Docket No. 72-1014  
Certificate of Compliance (CoC) No. 1014

Subject: Supplemental information for License Amendment Request #9 (LAR 1014-9) to  
HI-STORM 100 (TAC No. L24476)

**Response to NRC-Holtec Public Meeting Memo dated February 12, 2013**

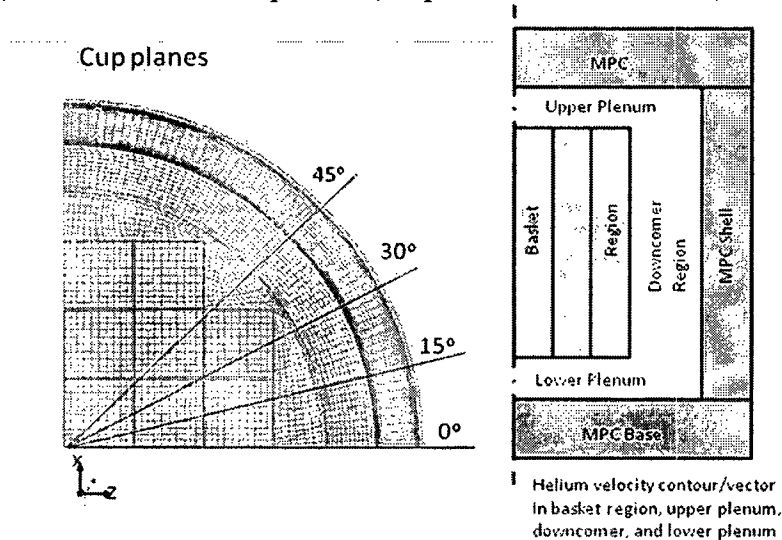
- b Application uncertainties. Uncertainty in the applied boundary conditions may lead to errors and differences between the exact solution and the discretized equations. Calculations on the applied boundary conditions should be performed to assess their sensitivity to the predicted peak cladding temperature.

The applicant should provide the difference (to PCT) contributed by each uncertainty and provide the PCT for the bounding ambient temperatures (with and without insolation).

To evaluate the uncertainty in applied boundary conditions, the following sensitivity studies were performed:

- (i) A sensitivity study was performed to study the effect of fuel thermal conductivity on PCT by reducing it by 10%.
- (ii) A sensitivity study was performed to study the effect of cask external surface heat transfer coefficient (h) on PCT by reducing it by 10%.
- (iii) A sensitivity study was performed to study the combination of the above two changes.

The PCT results for the above mentioned sensitivity studies are shown in the table below. These analyses were performed with the following input parameters:

- Fuel viscous resistance factor of  $1 \times 10^6 \text{ m}^{-2}$  for all three zones of fuel assembly
- 90% of design basis maximum heat load (Section 2.1.9 of HI-STORM 100 FSAR) and a regionalization parameter  $X=3$ ;
- 90°F ambient temperature with 10CFR71 insolation level.

The results show that the PCT under the worst combination of both reduced fuel thermal conductivity and heat transfer coefficient is still below the fuel temperature limit.

Figure 4.5.1: 3D QUARTER SYMMETRIC THERMAL MODEL OF THE HI-TRAC TRANSFER CASK

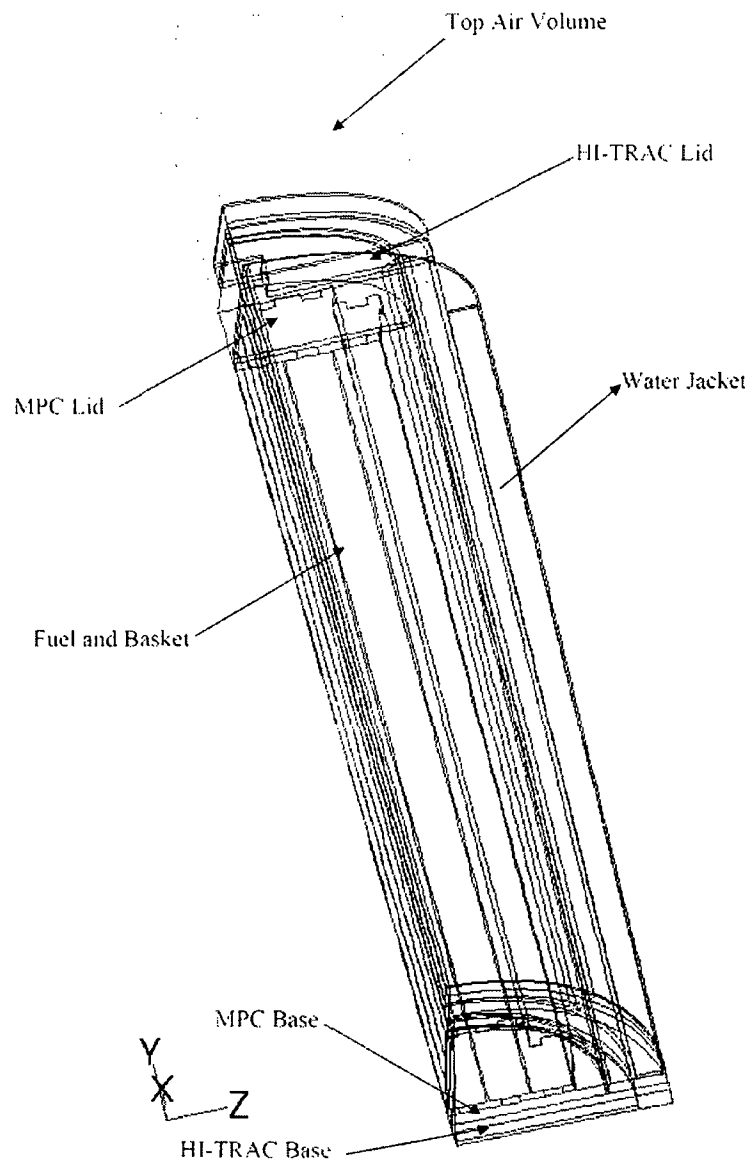
- 2 **The representation of fuel rods using porous media and effective thermal conductivity.** In the porous media approximation, fuel rods were approximated hydraulically by using frictional and inertial resistance. Also effective thermal conductivity was used to model radiation and conduction heat transfer in the fuel assembly instead of representing the real geometry. Effective thermal conductivity was also used in the air gap between the MPC and the transfer cask. Calculations should be performed to assess the sensitivity on the final results (i.e., peak cladding temperature (PCT)) to possible changes in frictional losses, inertial losses, and use of effective thermal conductivity.

For example, the staff performed some sensitivity calculations in the use of effective thermal conductivity in the air gap between the MPC and the transfer cask. The FLUENT model provided by Holtec was modified to represent the air gap to allow air motion as well as heat transfer by conduction and radiation. The water density in the water jacket was represented by using water density as a function of temperature. With these changes, the staff obtained a peak cladding temperature of 745°F as compared to Holtec's result of 738°F for the bounding case (X=3) and an ambient temperature of 110°F. The PCT predicted by the staff is below the allowable limit but this result does not include the discretization error or the application error, as explained later.

Holtec agrees with NRC staffs on explicitly modeling the annular air gap between the MPC shell and the HI-TRAC inner shell as fluid zone, instead of a solid zone having an effective thermal conductivity. The HI-TRAC thermal models were modified to model the annular gap explicitly.

The computational fluid dynamics model of the HI-TRAC transfer cask captures all essential details of the cask body including the radial ribs, lead, steel shells and the water jacket. Figures 4.5.1 show the discretization of the cask and its enclosed MPC for FLUENT implementation.
